CITY OF PATASKALA BOARD OF ZONING APPEALS

STAFF REPORT

Transportation Corridor Overlay District TCOD-22-003

TCOD-22-003 Staff Review

1 SITE LANDSCAPE PLAN
1"=20'-0"
NORTH

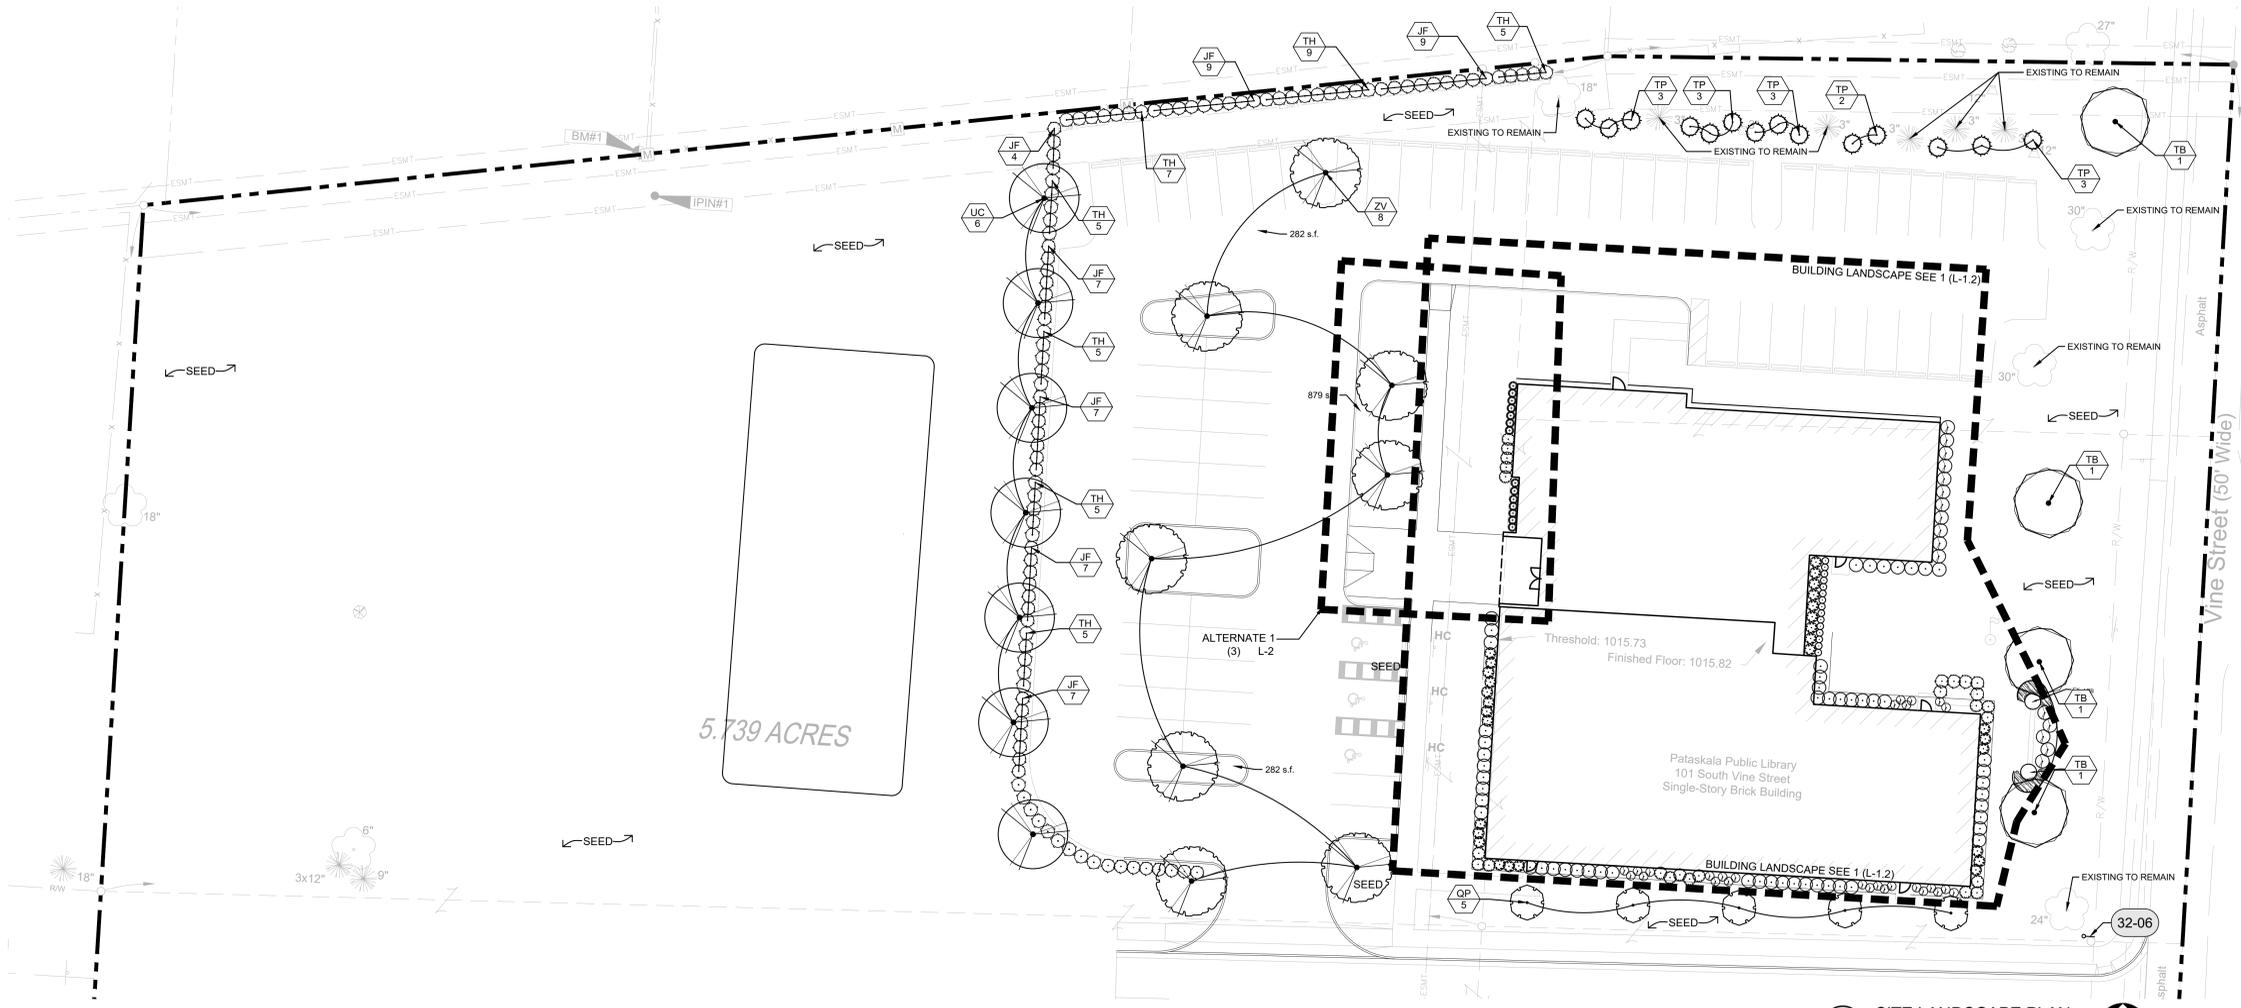
- Include note on front page that Access Drive is to be dedicated to City as R/W if this is still in the plans. I didn't see it mentioned anywhere.
- Parking Sign: Need more information. Height, size, location. Location appears to be at corner of Vine and Tyler but number doesn't match with number provided for sign.

- 1259.05 – Design Standards
 - 1259.05(D): Storage areas and trash storage receptacles shall be totally enclosed by structures or opaque fences on four sides and be located behind buildings.
 - Change note on L-1.1 to say “trash/refuse containers to be stored inside”

- Side Yard: L3 or L4 if abutting a residential use (North, South – If not being dedicated to public use)
 - North: Proposed – retain existing trees north of existing -parking, add 11 in this area. To north of additional parking area, add continuous shrub line of two (2) foot high shrubs.

- Note says to be maintained at four (4) feet in height. Add this note to all notes (front, side, rear yards) to cover the minimum three (3) foot height requirement.

3 DRIVE THRU ALTERNATE 1
1"=20'-0"
NORTH

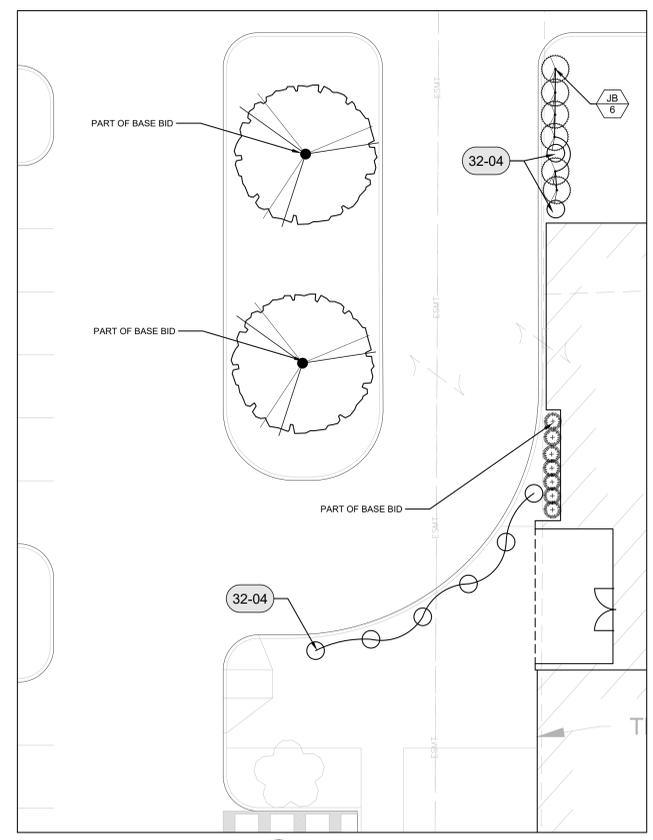
- Provide drive through width for alternate. Assuming one-way, will need signage.
